**8.1 REEVER & OCEAN PTY LTD - MATERIAL CHANGE OF USE - NATURE-BASED TOURISM - LOT 17 ON SP296830 & LOT 22 ON SP304952 - 112 BARNWELL ROAD, KURANDA - MCU/19/0018**

**Date Prepared:** 3 February 2020

**Author:** Planning Officer

1. Development application page 22, 3.3.14-Natural Hazard Mitigation.

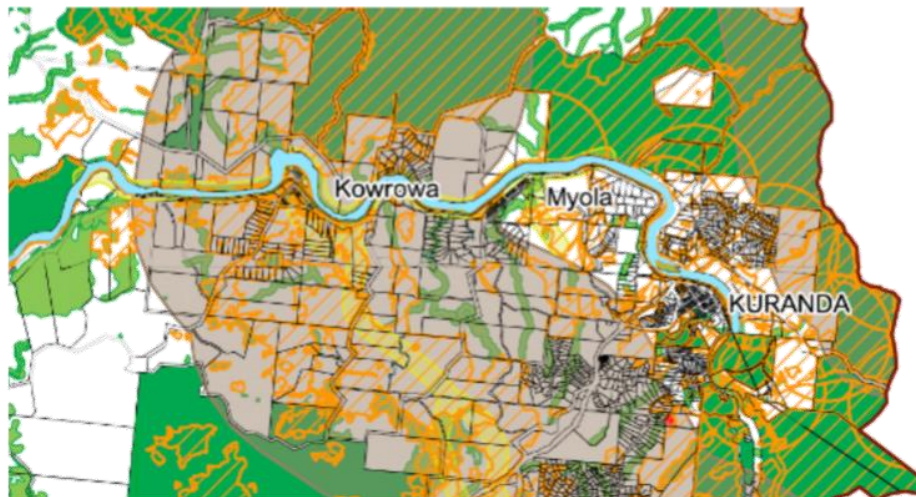
The applicant claims the site is not known to be located within a cyclone

impact area. This is not accurate as the whole of Mareeba Shire lies within the cyclone impact area.

The proposed development does not comply with cyclone building standards.
